# **Revised Hydrogeologic Report: Groundwater Mounding Analysis for Proposed Subsurface Disposal System**

Proposed Cascade Development  
115 Boston Post Road  
Wayland, MA

Project No. 17205

January 19, 2021

Figure 1. Overview of groundwater model setup. Borings and test pits without target heads not shown.

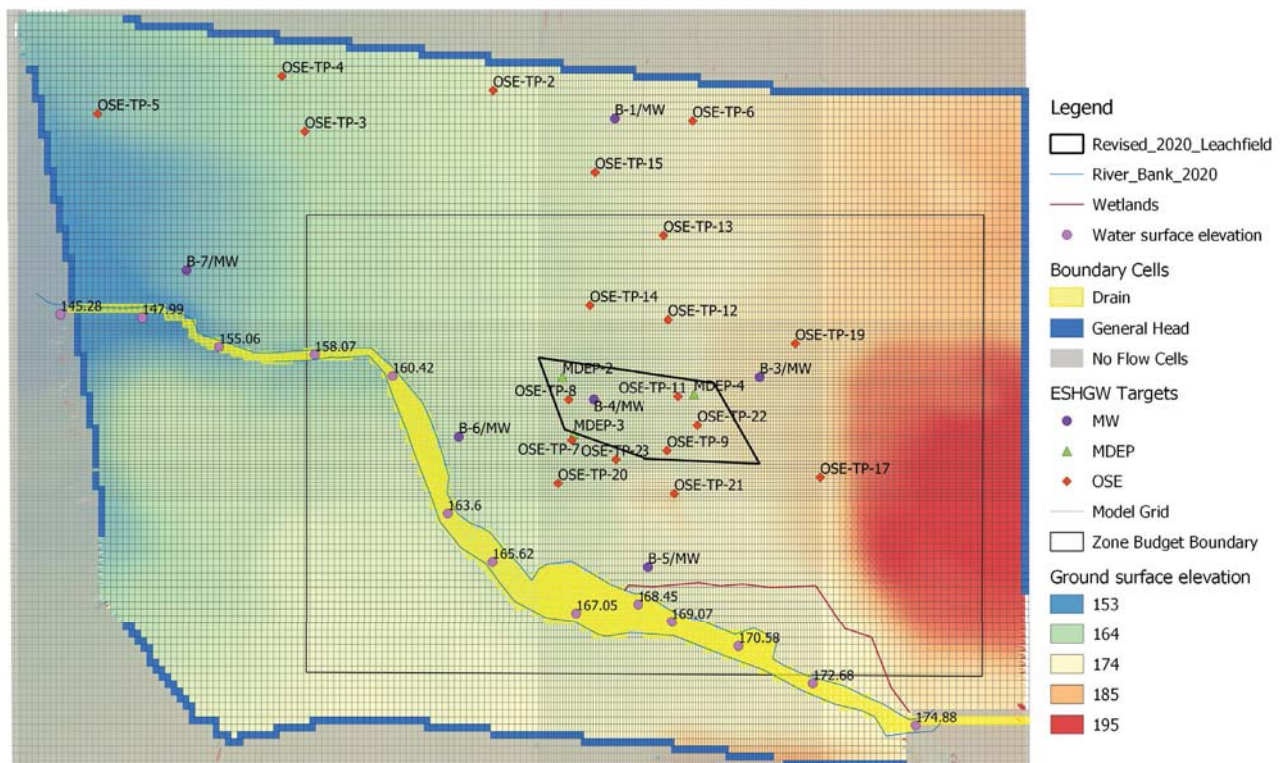
4. C. The particle tracking exercise performed to model the potential interaction with Pine Brook is depicted on Figure 6 in Appendix D. This figure shows that most particles pass through Pine Brook and exit along the western boundary. This simulation is not realistic, especially given the high groundwater elevation in this area. The particles would most likely discharge to Pine Brook. R. Correct. This was the result of the 2018 model not incorporating estimated seasonal high surface water elevations in Pine Brook into the model. As a result, the groundwater flow was modeled to flow beneath the brook. We have since incorporated surface water elevations into the revised 2020 model, and the assumption that groundwater will be in direct connection with the surface water in the brook.

Figure 2. Bottom of Layer 1 interpolated from borehole observations. Adjusted in vicinity of B-7 to facilitate model convergence.

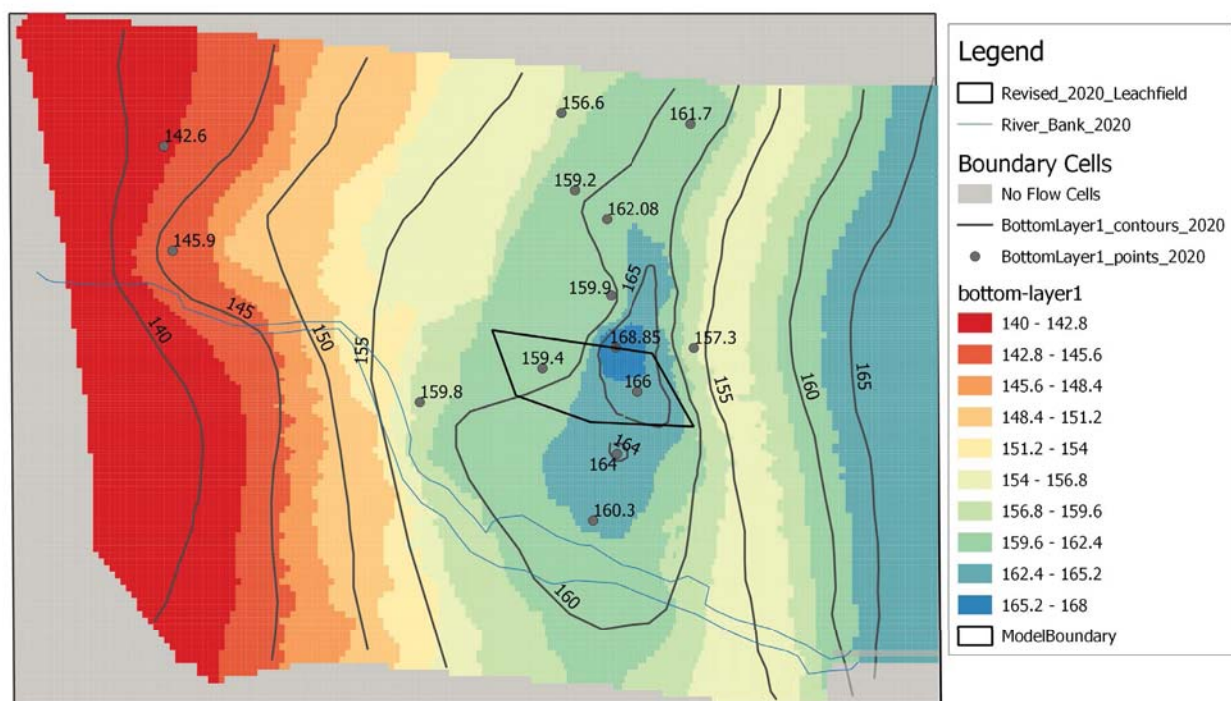
C. An updated site plan that shows the new outline/layout of the leaching area (and WWTF), any stormwater infiltration or detention area(s) and locations of all test holes, percolation tests, monitoring wells and respective logs. Due to ledge being encountered on the site in several deep test holes and in locations of attempted monitoring well locations, this information will be important for ensuring leaching and stormwater can meet design and regulation requirements. Test holes where ledge was encountered should be included/mapped and clearly identified on the site plan for understanding of the soils and refusal areas for site development/stormwater. R. Observations of “refusal” in test pits, where “ledge” or “boulders” were assumed/observed, have been incorporated into the model (see Table 1) and provide the transition elevation between Layer 1 (sand and gravel) and Layer 2 (dense silt/clay or ledge). See figures in Appendix D showing revised elevations of Layer 1 base.
